SUPPLEMENT TO STANDARD
OPERATION AND MAINTENANCE
MANUAL

LOWER SAN JOAQUIN RIVER AND
TRIBUTARIES PROJECT, CALIFORNIA

NORTH LEVEE OF STANISLAUS RIVER
AND EAST LEVEE OF SAN JOAQUIN RIVER
WITHIN R. D. NOS. 2064, 2075, 2094 AND 2096

Figure 1

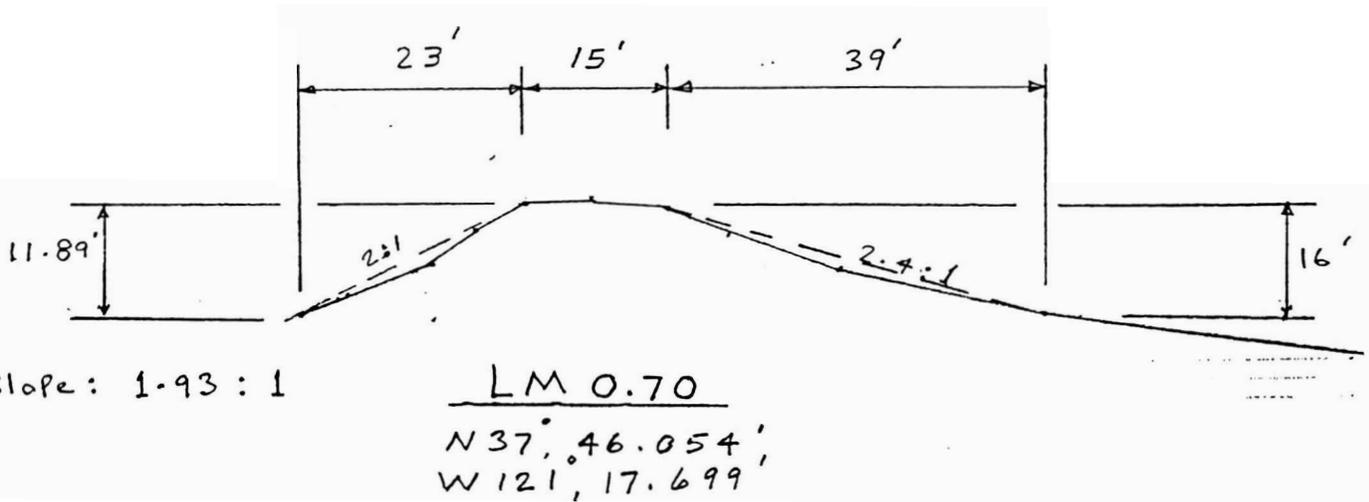
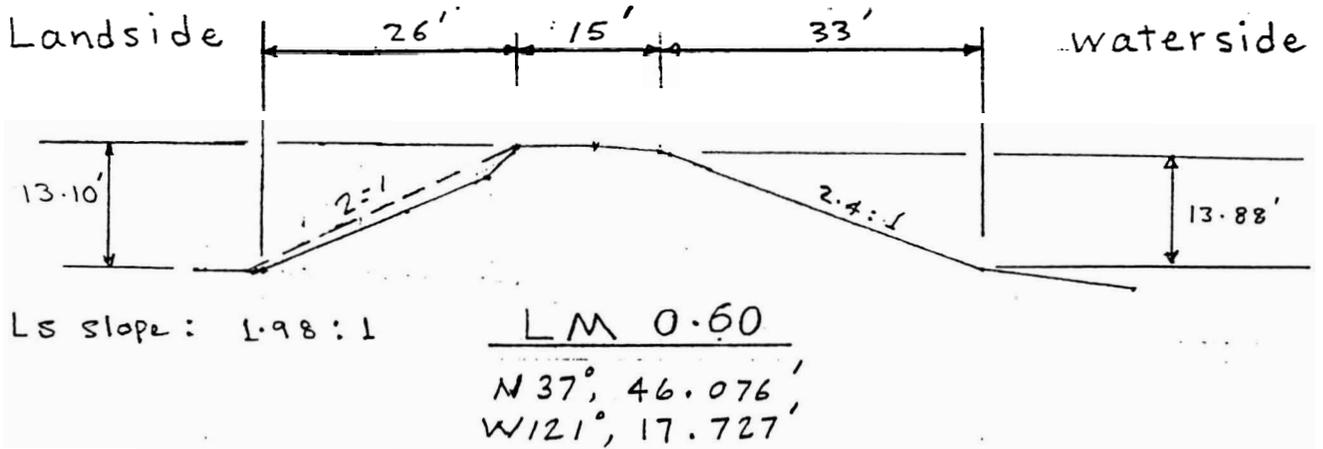
3. Levee slopes in the vicinity of the Site 583 levee breach repair appeared to have a slightly oversteepened landside slope. Cross sections surveyed on January 15, 2002 (See Figure 1), confirmed this observation. While both locations had an overall slope ratio of 2(H) to 1(V), the bottom of the slope was slightly flatter and the crest was slightly steeper. Slope geometrics observed were attributed to construction activities and/or minor surface erosion.

Mr. Mizuno asked if the PL 84-99 program could fund construction activities associated with flattening the landside levee slope in areas of concern. Unfortunately, this does not appear possible at this time. USACE representative Mr. Larry Bergmooser stated he currently had neither the authority nor available funding. However, Mr. Bergmooser did indicate that during future flood emergencies, the Corps would be available to provide assistance under PL 84-99 authority. The need for careful performance monitoring as well as timely requests for technical assistance was stressed.
